SERVICE BULLETIN

Communication #: I-18-03

VERSION: R01 (May 29, 2018) VOLUNTARY COMPLIANCE RECALL

SUBJECT: 2014-2018 INDIAN MOTORCYCLE (111 C.I.) EVAP EMISSIONS UPDATE

KIT CONTENTS (P/N 2207750)

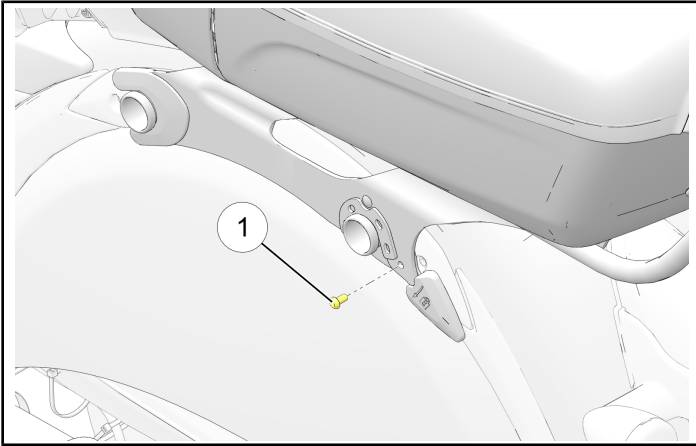
Indian Motorcycle engineering has determined that the evaporative emission control system of some 111 c.i. models, designated for sale in the State of California and Internationally, may not function as intended under certain conditions where water may unexpectedly enter the Carbon Canister. 2014–2018 motorcycles are subject to CARB regulations, while 2017–2018 motorcycles are subject to regulations set forth by EU directive EC 168/2013.

Please follow the instructions outlined in Service Bulletin I-18-03 to install a new Carbon Canister kit based on the motorcycle mileage and registrations status as outlined in Part A of this bulletin.

REF	PART DESCRIPTION	PART NUMBER	QTY
①	Carbon Canister	2522050	1
②	Compression Limiter	5142474	2
③	Heat Shield	5266749-329	1
④	Grommet	5415428	2
⑤	Vent Line	5455548	1
⑥	Strap	7080492	1
⑦	J-Clip	7080884	1
⑧	Screw	7517770	2

KIT CONTENTS (P/N 2207751)

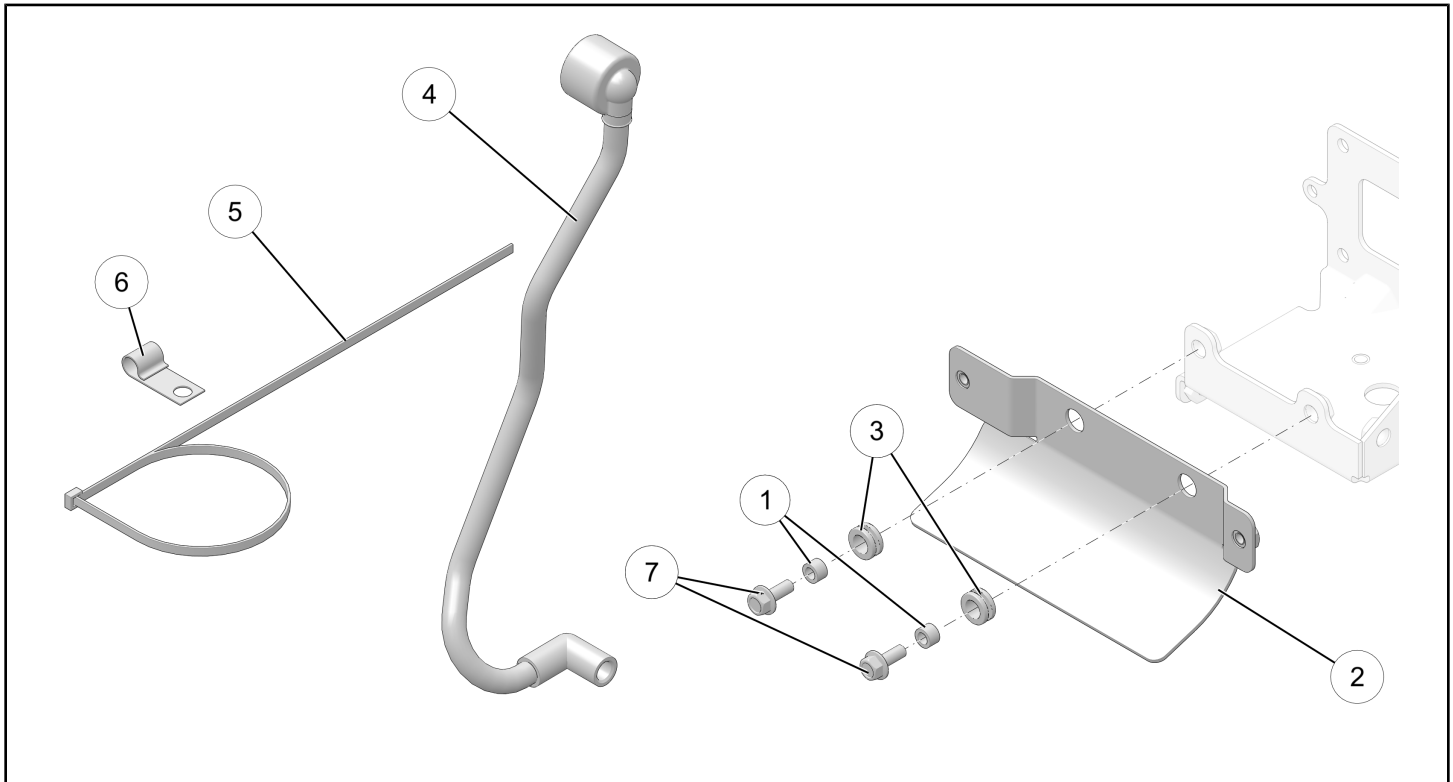
I-18-03-B CARBON CANISTER VENT LINE INSTALLATION (FOR MOTORCYCLES WITH LESS THAN 10 MILES ON THE ODOMETER)

REF	PART DESCRIPTION	PART NUMBER	QTY
①	Compression Limiter	5142474	2
②	Heat Shield	5266749-329	1
③	Grommet	5415428	2
④	Vent Line	5455548	1
⑤	Strap	7080492	1
⑥	J-Clip	7080884	1
⑦	Screw	7517770	2
